PROPERTY OF BETTY LAUFER
ARBUTUS ST. & LIVINGSTON RD., MIDDLETOWN, CONN.

SITE DEVELOPMENT

DATE: JULY 1980
SCALE: 1"=20'
DRAWING Nº 2 OF 2

MAP NOTES.

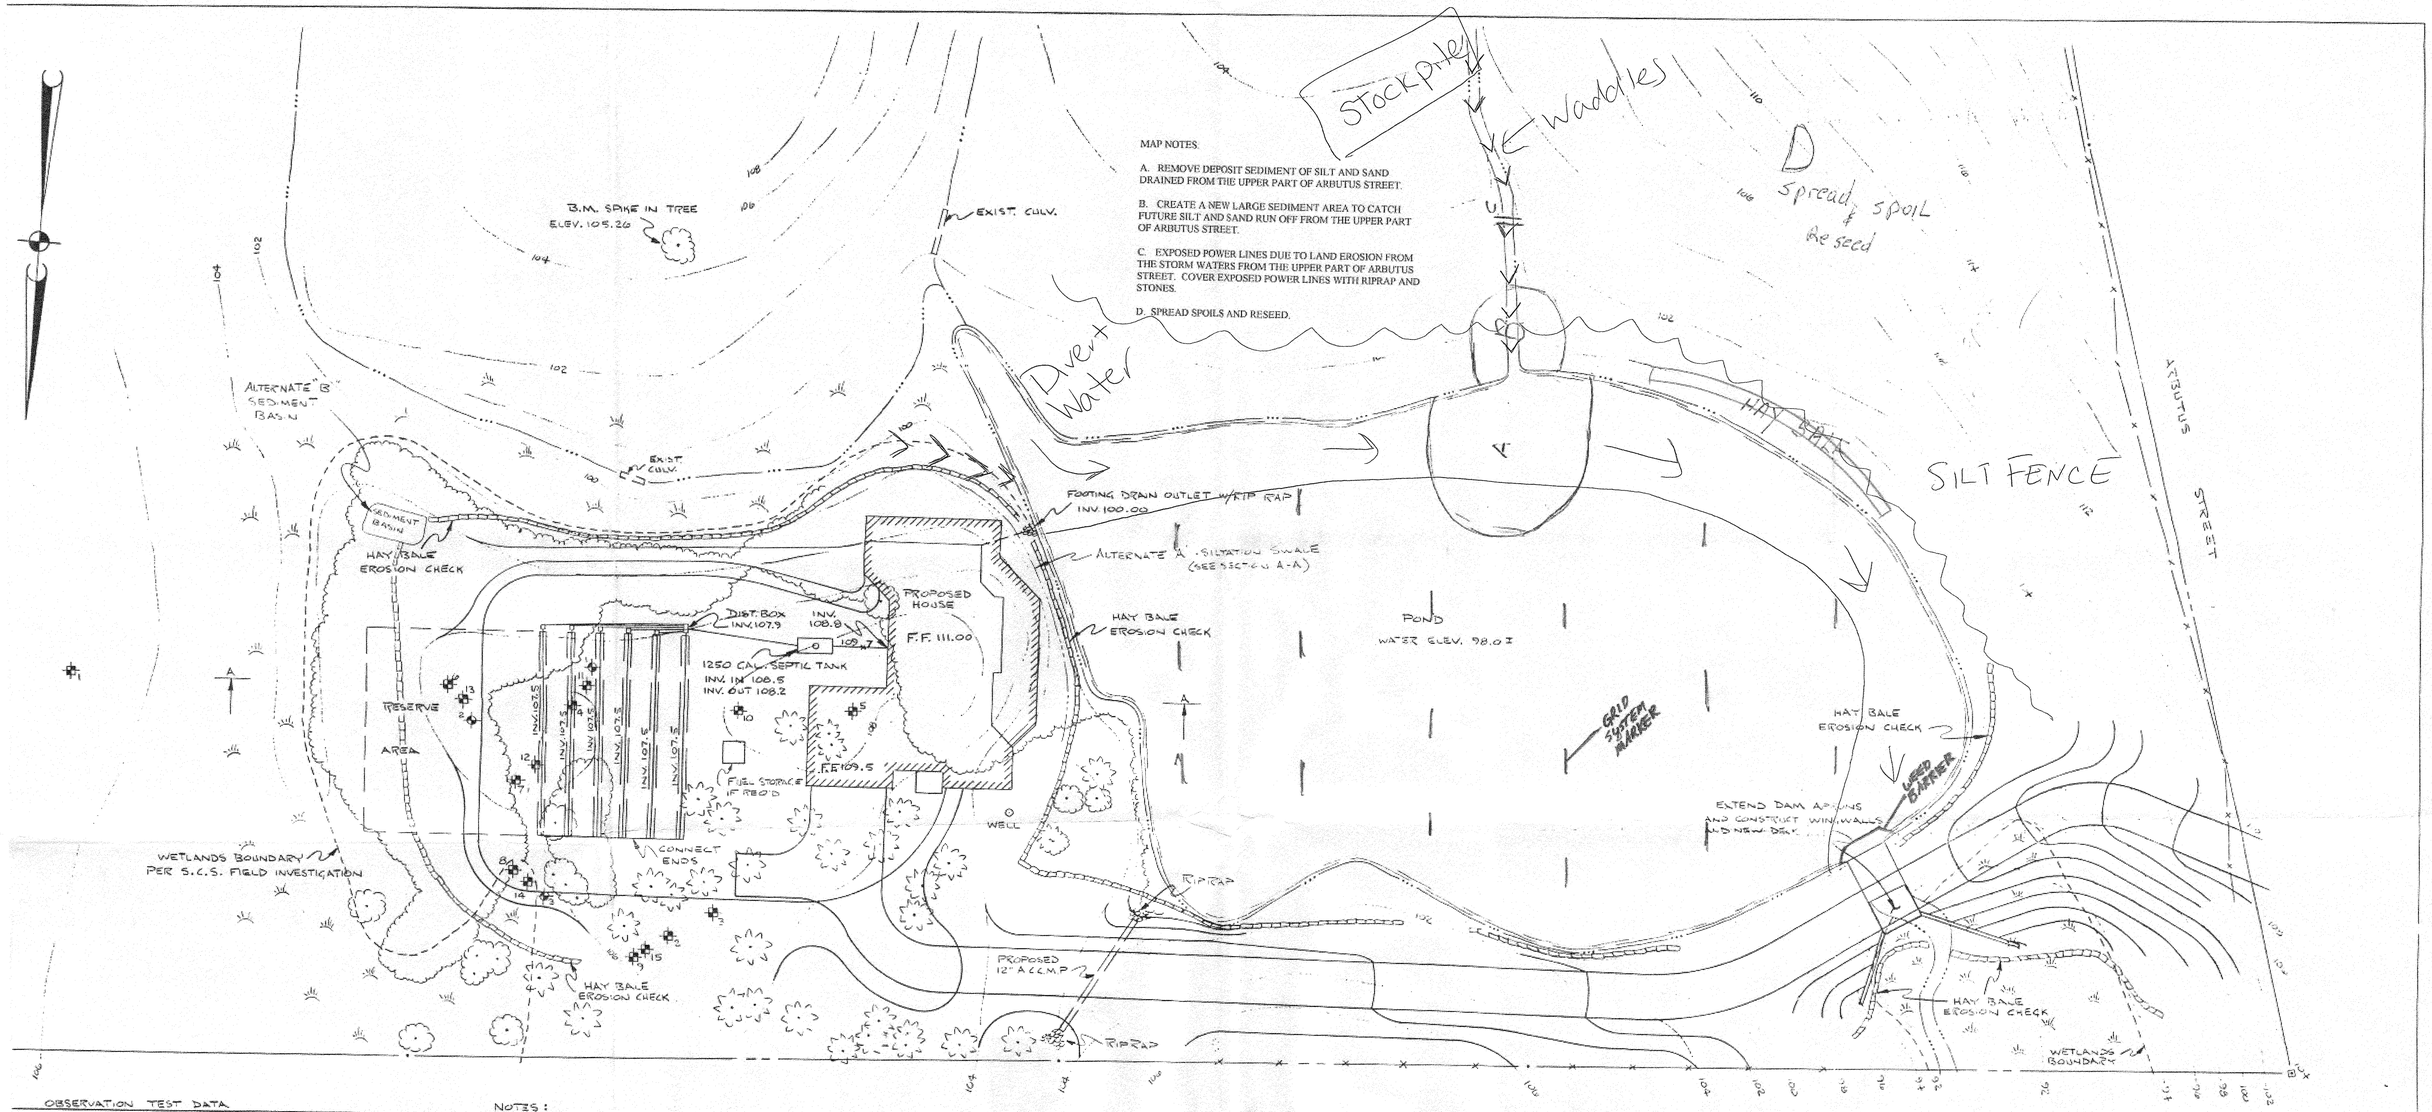
A. REMOVE DEPOSIT SEDIMENT OF SILT AND SAND DRAINED FROM THE UPPER PART OF ARBUTUS STREET.

B. CREATE A NEW LARGE SEDIMENT AREA TO CATCH FUTURE SILT AND SAND RUN OFF FROM THE UPPER PART OF ARBUTUS STREET.

C. EXPOSED POWER LINES DUE TO LAND EROSION FROM THE STORM WATERS FROM THE UPPER PART OF ARBUTUS STREET. COVER EXPOSED POWER LINES WITH RIPRAP AND STONES.

D. SPREAD SPOILS AND RESEED.
